Amendments to the Drawings

Appl'n No.: 10/811,300
Title: Robust Piezoelectric Power Generation Module
Inventors: Alessandro Pizzochero et al.
Annotated Marked-Up Drawings

FIG. 1A

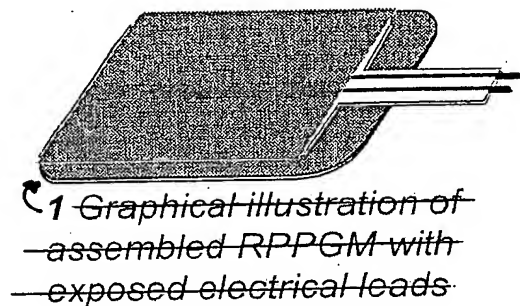
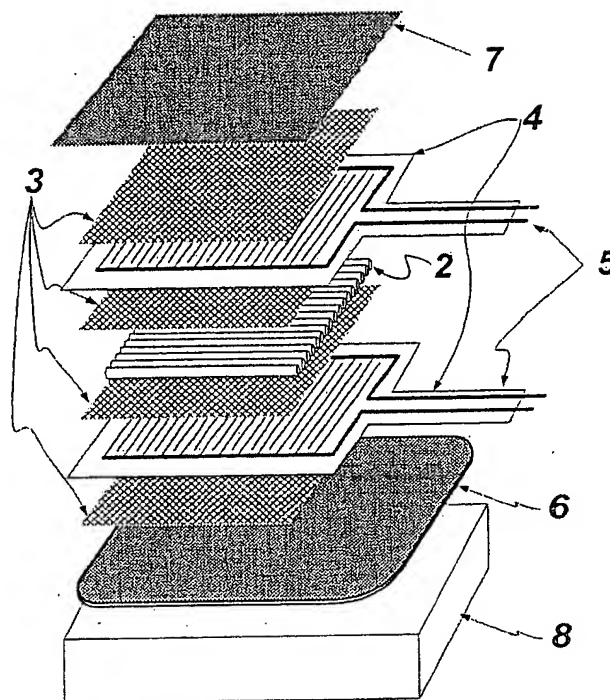
Fig. 1 is being amended to be labeled as Figs. 1A and 1B, and indicated by way of mark-ups in a legend on page 1/9 of the enclosed Annotated Marked-Up Drawings and as indicated in the enclosed Replacement drawings. Descriptor text is being deleted below Figs. 1A and 1B. The descriptions are being added by way of amendment to the specification on page 5, line 18. No new matter is being introduced by way of this amendment.

FIG. 1

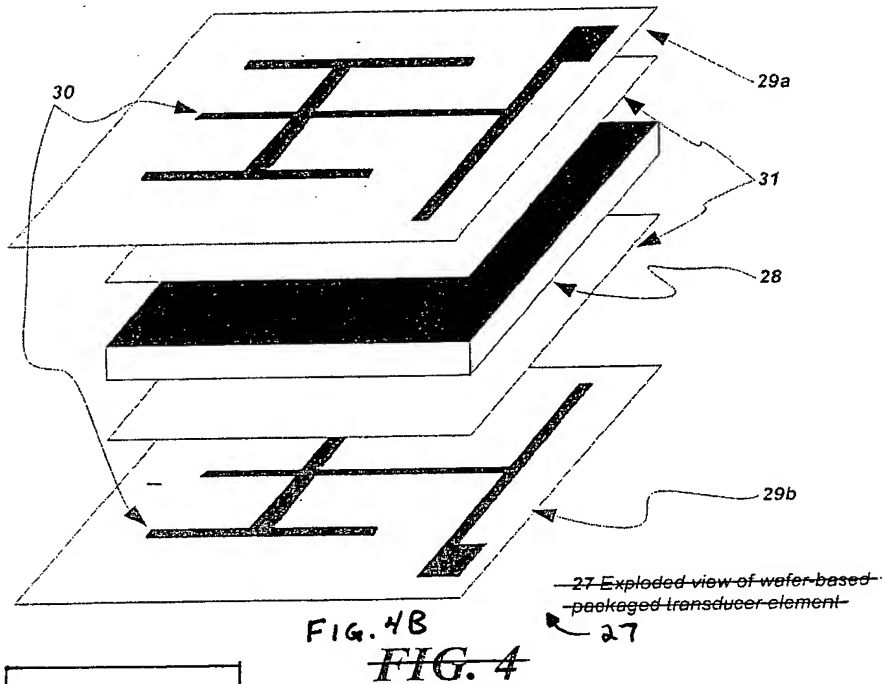
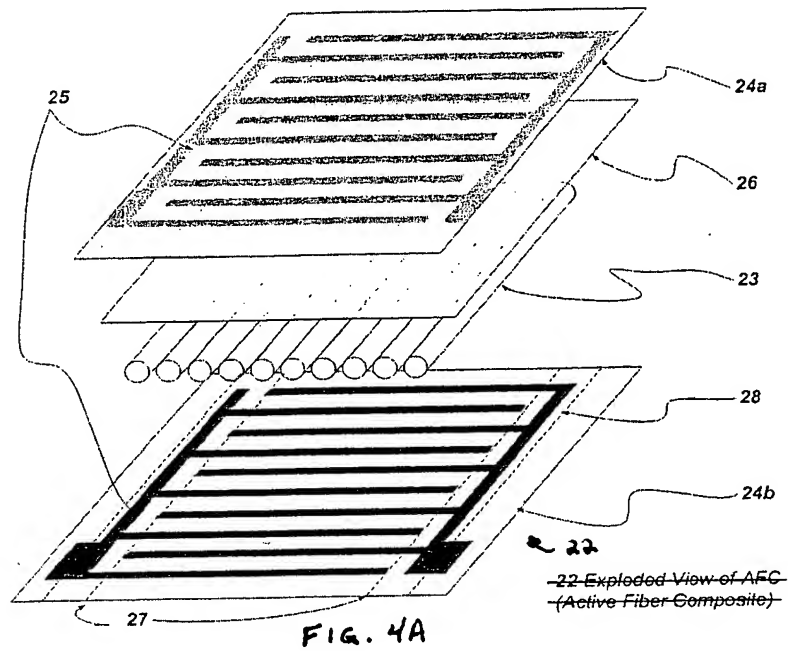
Fig. 4 is being amended to be labeled as Figs. 4A and 4B. A legend is being added to indicate same. Descriptive text in Fig. 4 is being deleted, but it is included in the specification as originally filed at page 8, line 17 in reference to Fig. 4.

FIG. 9

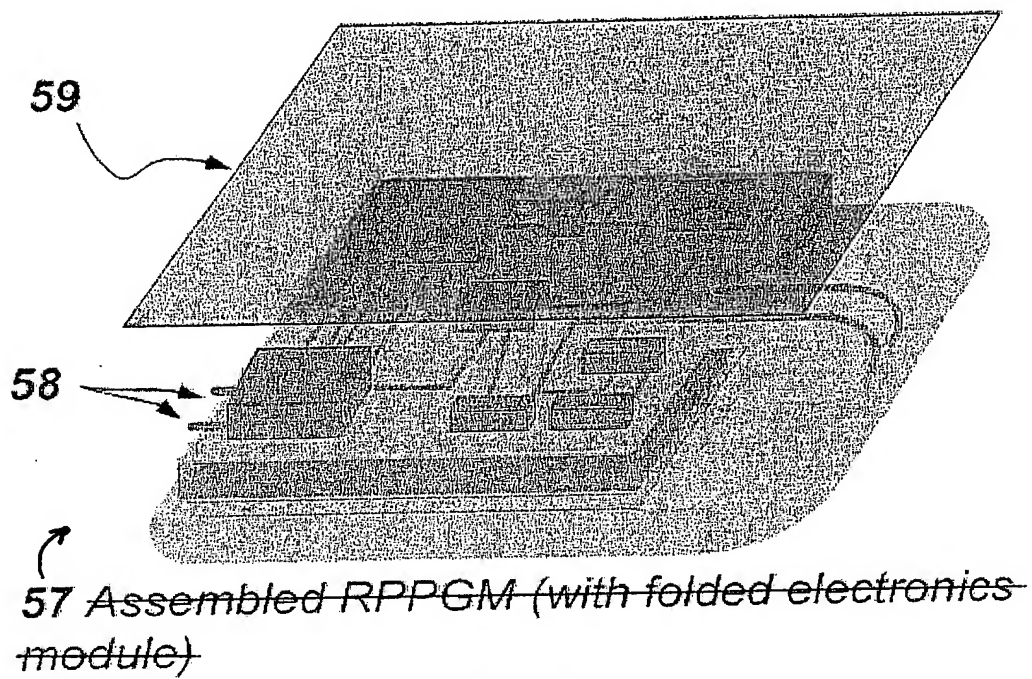
Fig. 9 is being amended to remove descriptor text that is included in the specification as originally filed in the Brief Description of the Drawings and page 17, lines 4-15.

FIG. 10

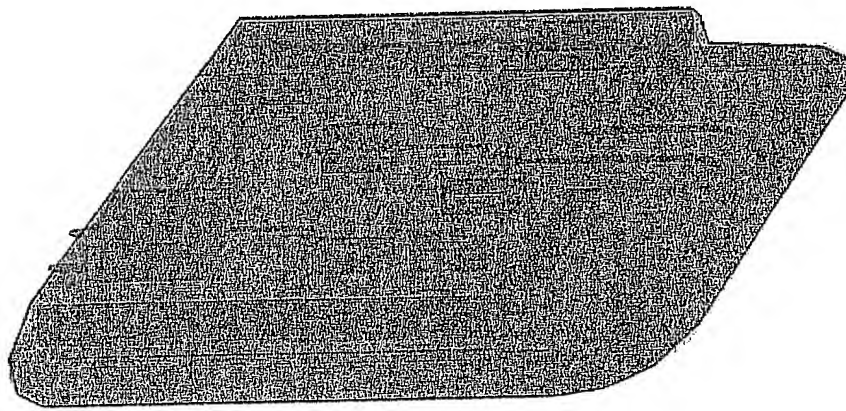
Fig. 10 is being amended to remove "RPPGM Module." The brief description of Fig. 10 on page 5 of the specification as originally filed and the detailed description of Fig. 10 on page 17 of the specification as originally filed indicate that Fig. 10 is an RPPGM Module.
